Technical Memorandum

Prepared For: Eureka County Board of Commissioners

Prepared By: Carol Oberholtzer (Lahontan GeoScience, Inc.)

Date: November 24, 2010

FIGURE 6. KOBEH VALLEY ET

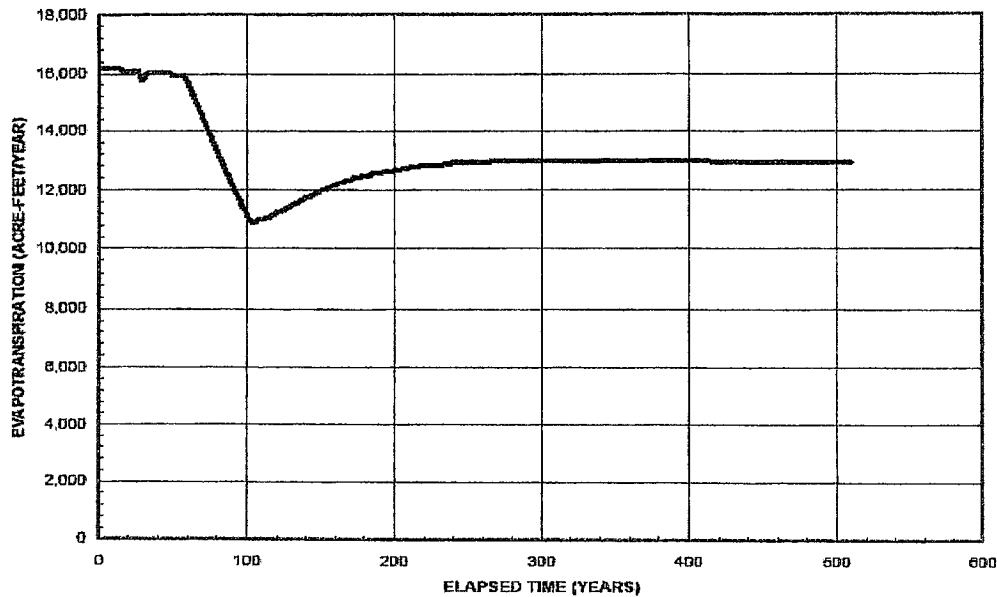
To further evaluate this affect, a HSU (Hydrostratigraphic Unit) report was generated for all fluxes in the model per the Kobeh Valley HSU for all years through year 222. ET is depicted in Figure 6 as a graph of ET over time in Kobeh Valley. As seen in this figure, ET begins at about 16,000 A/Y (acre-feet per year) in year 0 representing 1955, it drops around year 56 when mining pumping begins and decreases to about 11,000 A/Y when mining stops. ET then rebounds a little when mining stops at year 2055 around year 101 on the x axis of the graph. The ET amount stabilizes at around 12,000 A/Y after this time indicating a semi-permanent reduction. The issues regarding the ET not occurring where expected and the semi permanent ET impact need to be addressed.

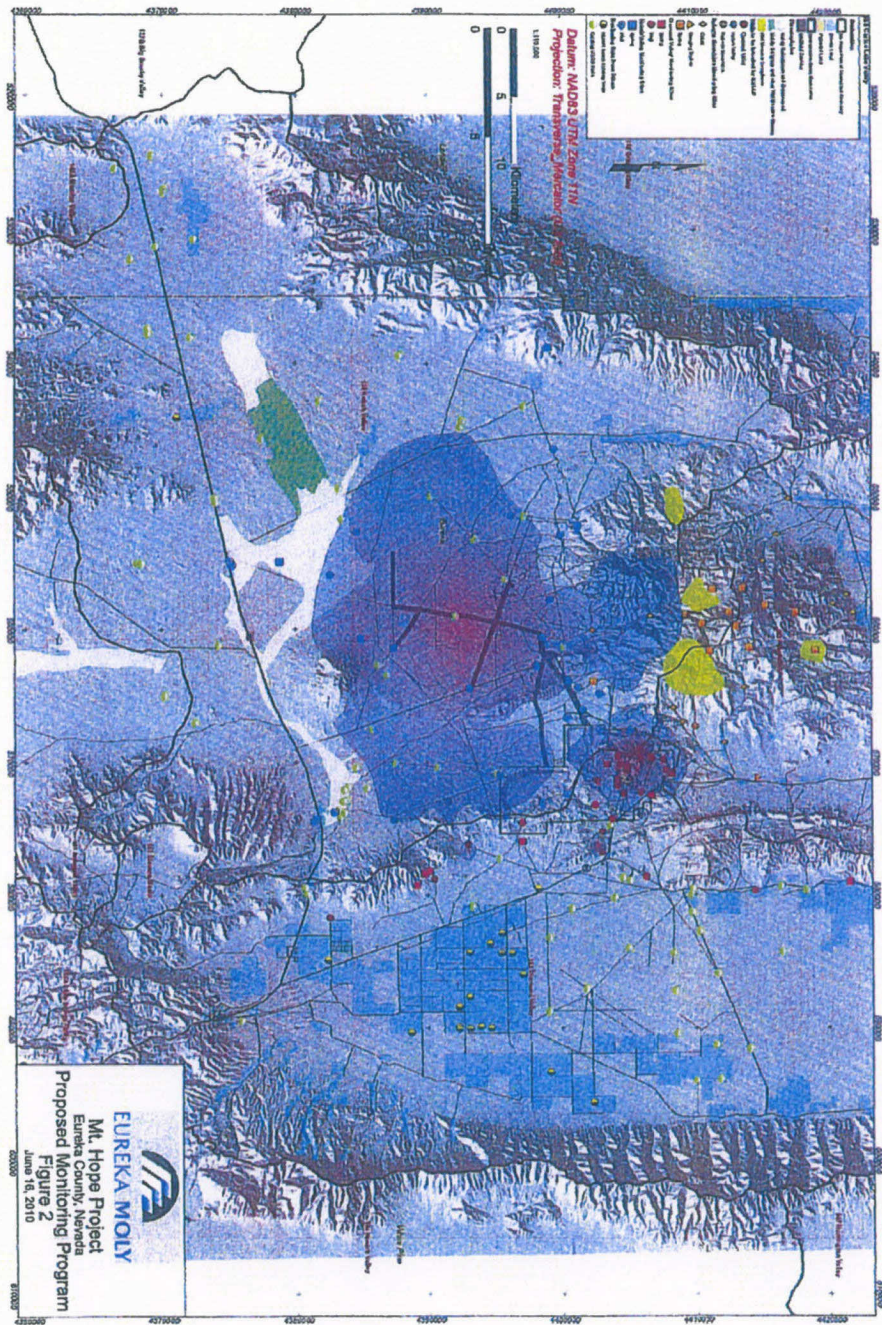
To evaluate the amount of water coming from Pine Valley and the Garden Valley Sub-basin of Pine Valley to Kobeh Valley, a HFB or hydraulic flow boundary was placed between the two boundaries between the east side of Roberts Creek and the mine pit. In the steady state model simulation (Figure 8) the model was run. Simulating the influence of the hydraulic flow barrier (HFB) results in minimal impact to flow with some velocity vector magnitudes reduced. Flow continues with the assigned hydraulic conductivity value in the HFB. Increasing the K value would no doubt decrease the flow through the barrier further.

FIGURE 2. DRAWDOWN AT HEADWATERS OF HENDERSON CREEK

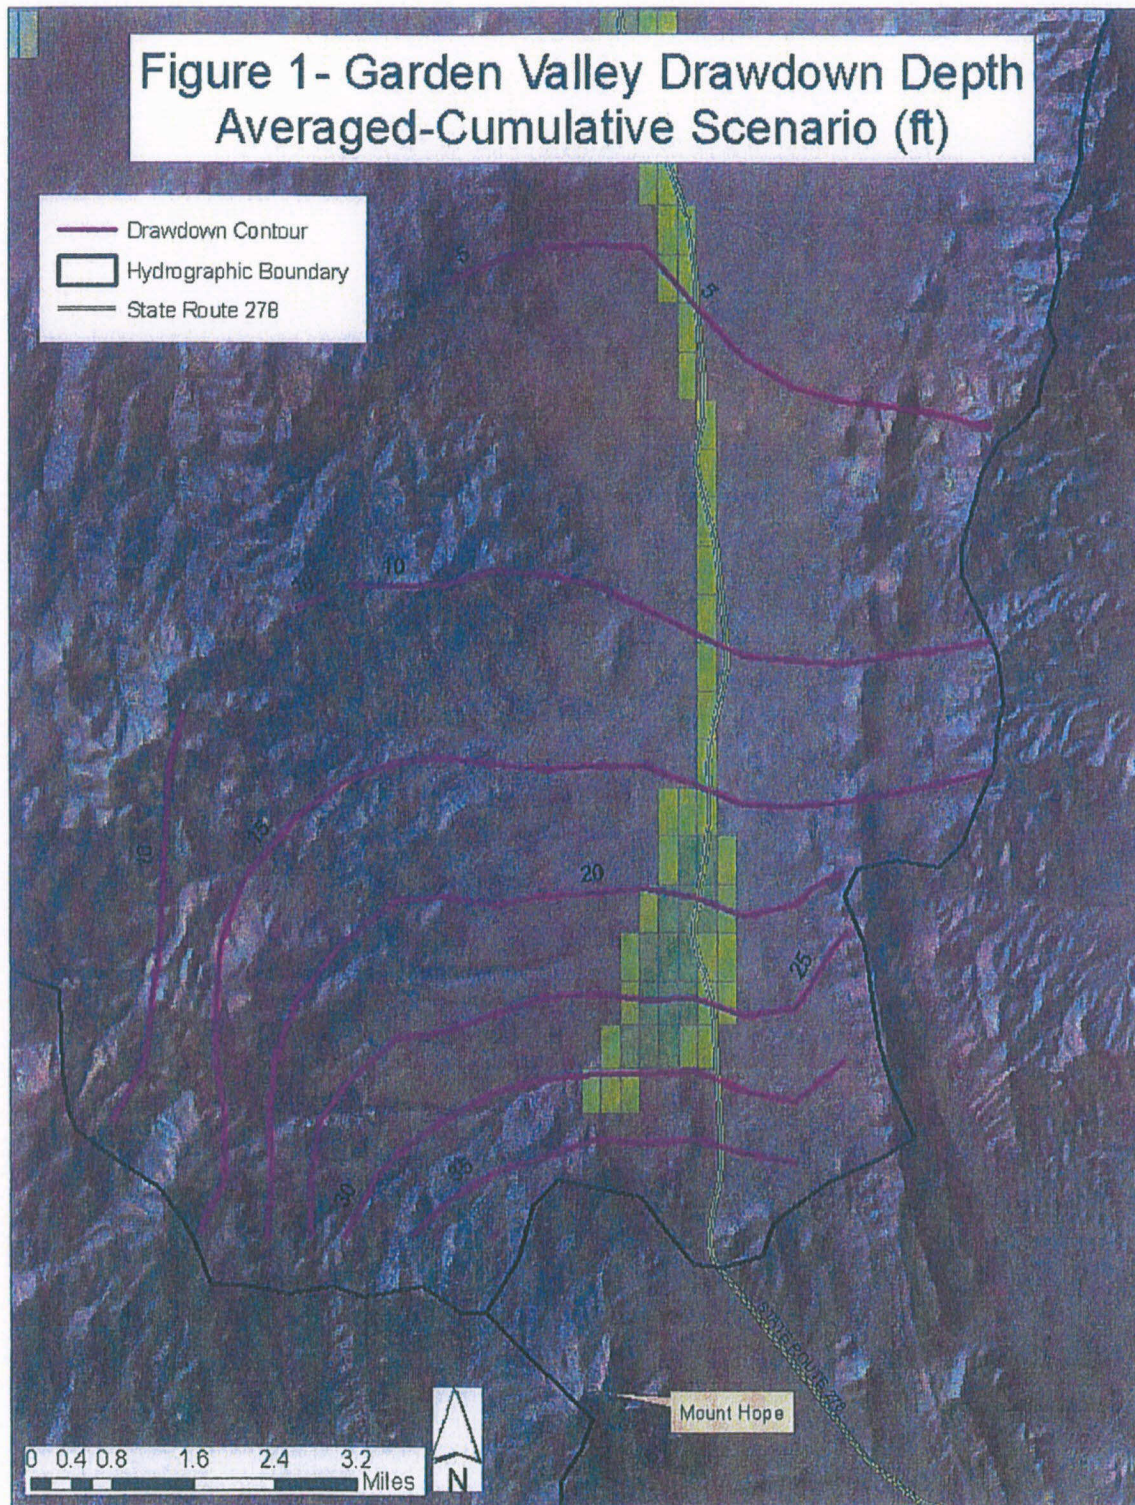
Using the mine pumping alone, the 5 foot line is adjacent to the S Fork of Henderson Creek (See Figure 3.4-8 the mining only pumping 5 foot contour figure used in Dale Bugenig's memorandum) thereby potentially impacting flows to or from the creek. However, as stated before showing just the 5 foot contour does not tell the whole story. When taking the mining only scenario and allowing the maximum 35 feet of drawdown near the southern end of Garden Valley, as depicted in Figure 1, groundwater flow clearly is southerly for year 2055. Hydrographs of drawdown versus time for the wells in the north fork of Henderson Creek, and the confluence of the Henderson Creek forks for layer 1 in the cumulative pumping scenario (Figures 2 and 3) show drawdown increasing linearly until approximately the year 200 where the rate of increase decreases slightly.

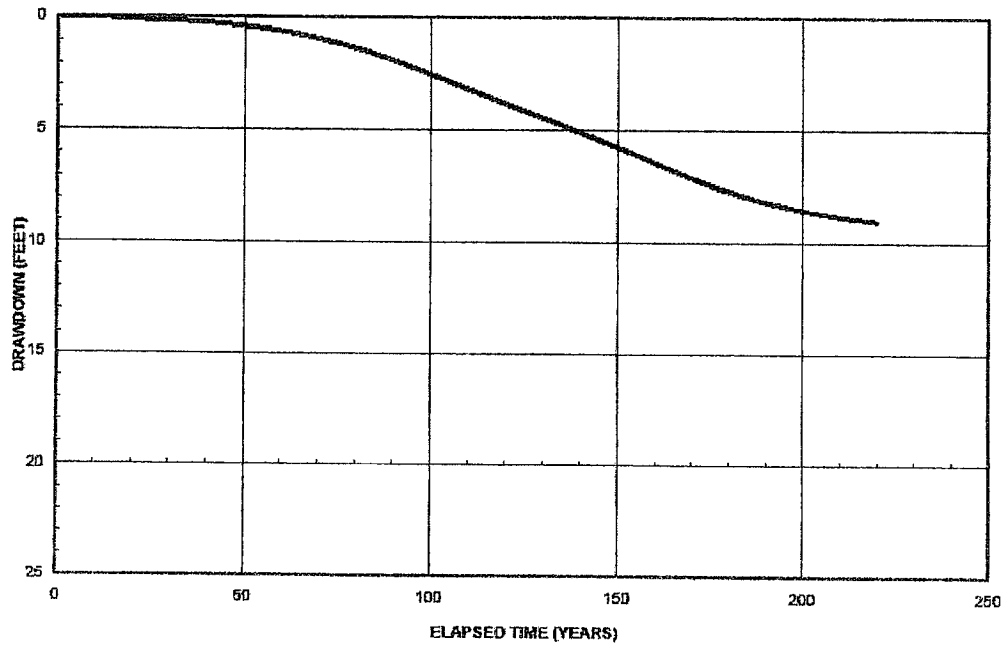
Flux between Garden and Kobeh Valleys was evaluated for the entire model period as shown in the attached graph for the cumulative scenario. As seen in Figure 4, the flux out of Garden Valley, where the creeks in question are located, began to decrease when mine pumping began in about year 56 after steady state year 1955. It decreases until year 101 when mining pumping stops. This may be due to the flow direction shifting due to the influence of pumping in Kobeh Valley. It then increases dramatically after mining stops in year 101 or 2055. This indicates a direct influence on Henderson Creek and Garden Valley from mine pumping.

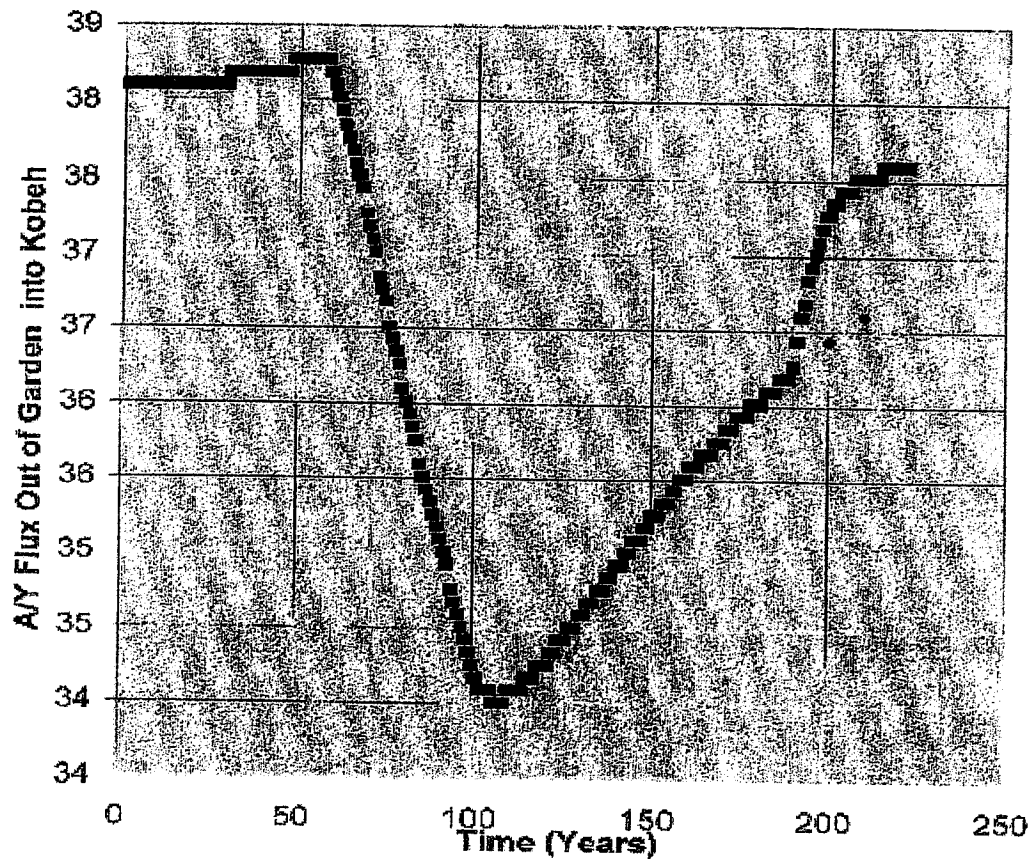
A similar analysis was made for the Diamond Only pumping scenario. Figure 5 depicts Garden Valley only with drawdown from Diamond Valley pumping only. The drawdown ranges from 25 feet in the south to 5 feet north of the confluence of Henderson Creek south and north. This indicates that the total drawdown occurring from Diamond Valley is more than from Diamond alone as there is a total of 35 feet of drawdown under the cumulative scenario. Subtracting 25 feet from the same area for Diamond only pumping indicates that mining is causing about 10 feet of drawdown in this same area. It should be remembered that these contours are averaged over the entire model, so drawdown will be the same for all layers, therefore, drawdown in a specific layer may differ from the average depicted in the figure.

Figure DCB-2

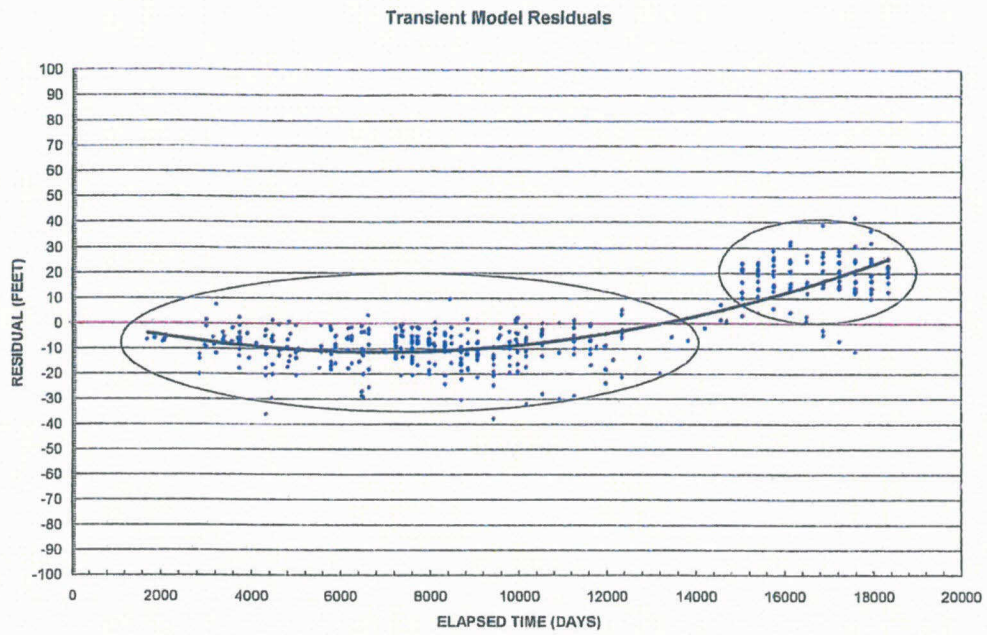
Alternatively, the trend of residuals might be construed to mean the model may not accurately portray the agricultural pumping in Diamond Valley since the early 1990's. The information provided in Figures DCB-1 and -2 may represent a "step function" indicated by the two groupings shown in figures, suggesting that model input (agricultural consumptive use in Diamond Valley) since the 1990s simply may be incorrect. Whatever the cause, prior to the 1980s, computed water levels were higher than observed levels by generally 10 to 20 feet and after the 1990s computed water levels were lower than observed levels by 10 to 30 feet. The mine's consultants expended considerable effort to identify the cause for the observed data trend, to no avail, and finally concluded the calibration was good enough.

Whatever the reason, the inference drawn from the plots is that the model may over-predict future drawdown due to pumping in Diamond Valley. This is important because the model suggests the effects of Diamond Valley pumping will propagate to the adjacent basins. If, in fact, the model over-predicts drawdown in Diamond Valley, and drawdown in adjacent basins arising from Diamond Valley pumping should be less, then the proportion of impacts in adjacent basins attributable to the mine's groundwater extractions in Kobeh Valley and at Mt Hope will be larger than the model predicts.

Figure DCB- 3

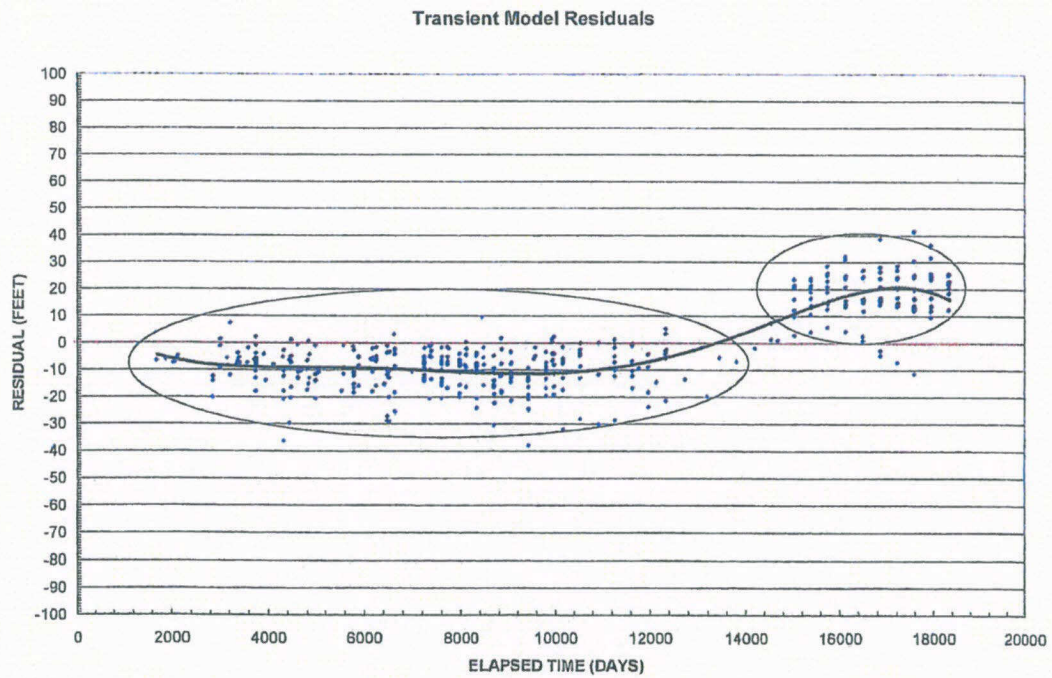
Historical water levels in wells in Diamond Valley were vital to calibrating the transient groundwater flow model necessary for predicting changes arising from the mine's pumping. Review of the hydrographs for selected wells provided in the current report compare observed and model-simulated water levels versus time (Montgomery, *et al.*, 2010; Figures 4.1-33 through 4.1-46) show generally good correlation from the beginning of the simulation through about 1985, after which there is a departure between observed and simulated water levels, *e.g.*, the model simulates more drawdown than that which was observed in many of the wells. Another way to look at the overall trend is to plot the residuals from the wells used as calibration targets on a single graph. The residuals for calibration points in the model are provided in the report appendix and these were plotted versus time in Figure DCB-2, below. A second-order polynomial trend line can be fit to the data that accounts for approximately 80% of the variance of the residuals. This trend suggests that predictions of future drawdown in Diamond Valley may over-predict drawdown. A fifth-order polynomial provides a slightly better fit to the residuals, accounting for 83% of the variance (Figure DCB-3).

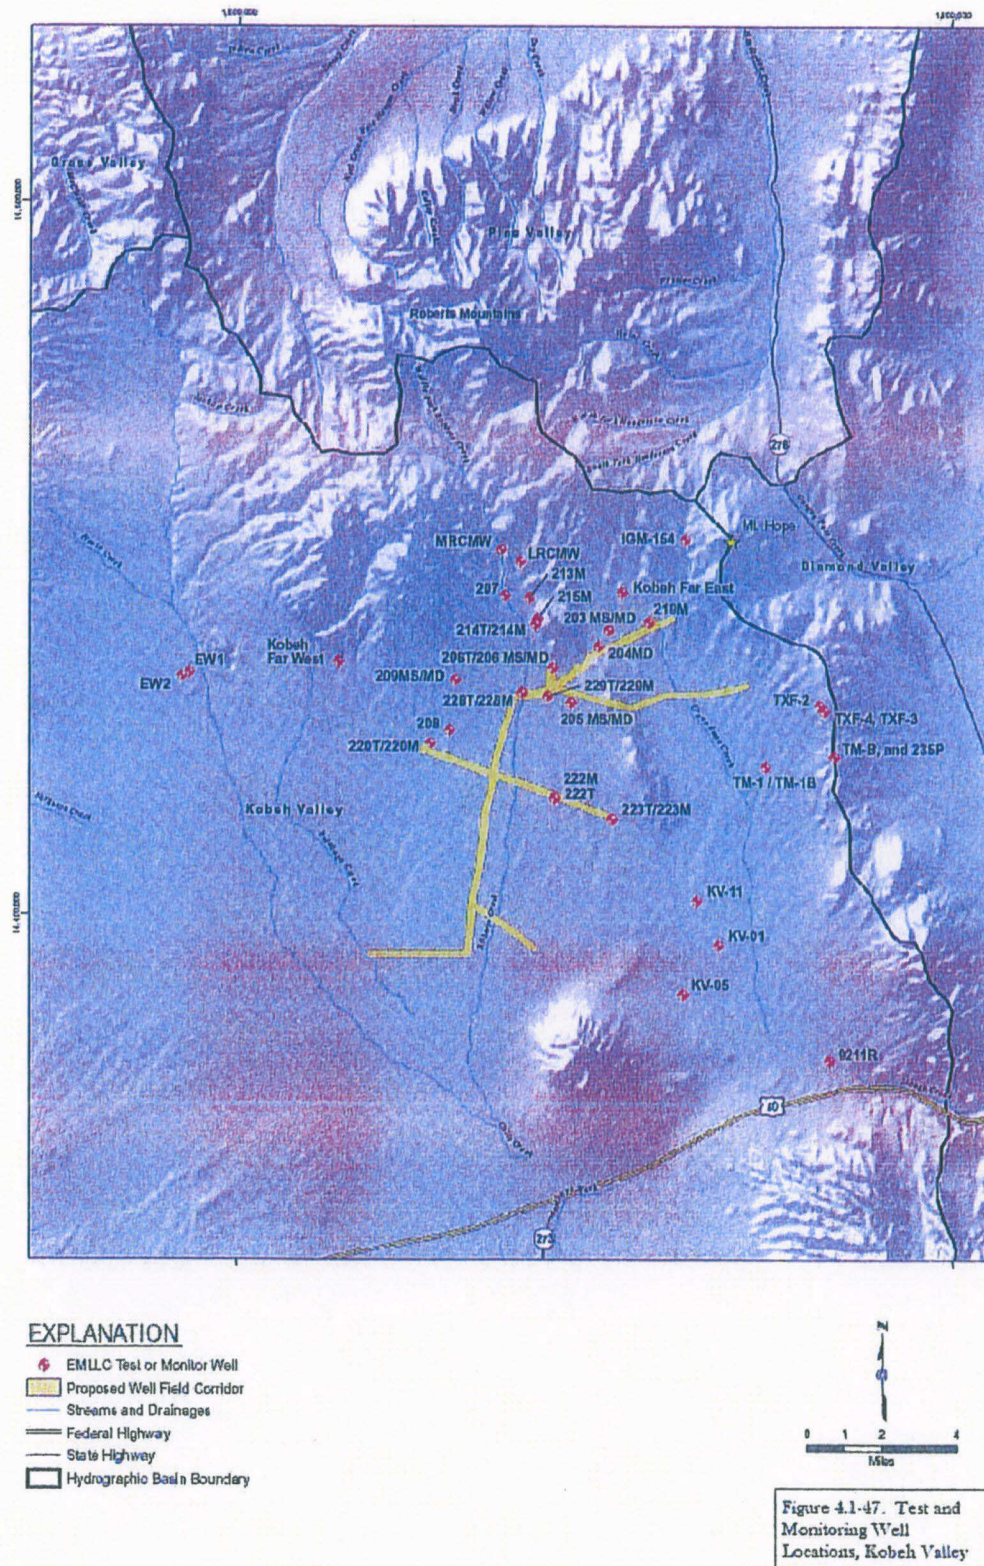
There are little historical data available with which to calibrate the transient model for Kobeh Valley, in general, and the wellfield area, in particular. The pumping tests of exploratory wells in Kobeh Valley (see Figure 4.1-47 below) offered an opportunity to provide aquifer properties needed for predicting future changes in water level near the wellfield. Analysis of the test data was accomplished by both analytical means and by using MODFLOW. Figures 4.1-48b, 4.1-50 and 4.1-52 (Montgomery, *et al.*, 2010), below, were proffered in the report as evidence that the model accurately portrays the response in the aquifer to testing:

Figure 4.1-48b. Observed and Simulated Water Level Drawdown during Testing at Well 214P

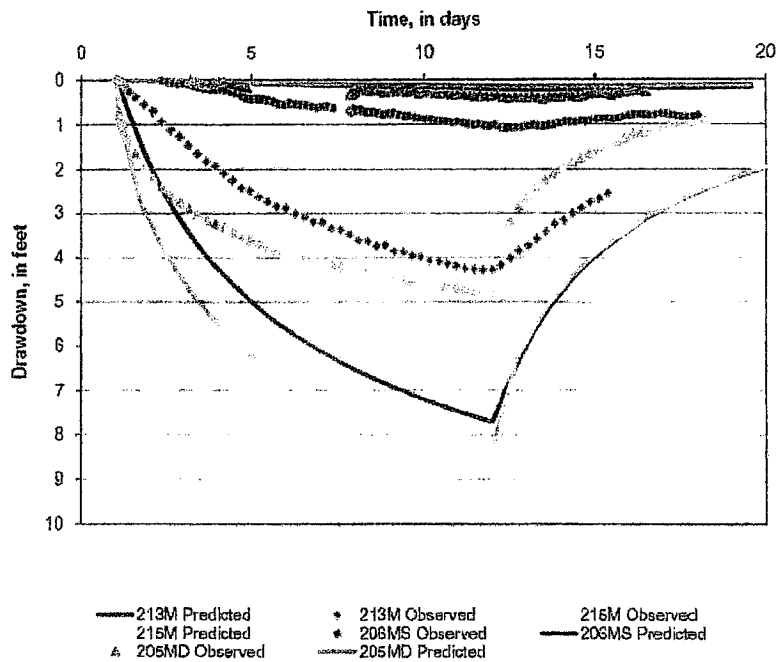
In the absence of a quantitative assessment of the data analysis in the model report, I would draw a much different conclusion, based on my experience analyzing test data from literally thousands of aquifer tests. At the very best, the graphs show that water levels decline when the pump is turned on and begin to recover when the pumps are turned off. The simulated data do not capture the shape of the observed data plots nor do they replicate the observed drawdown.
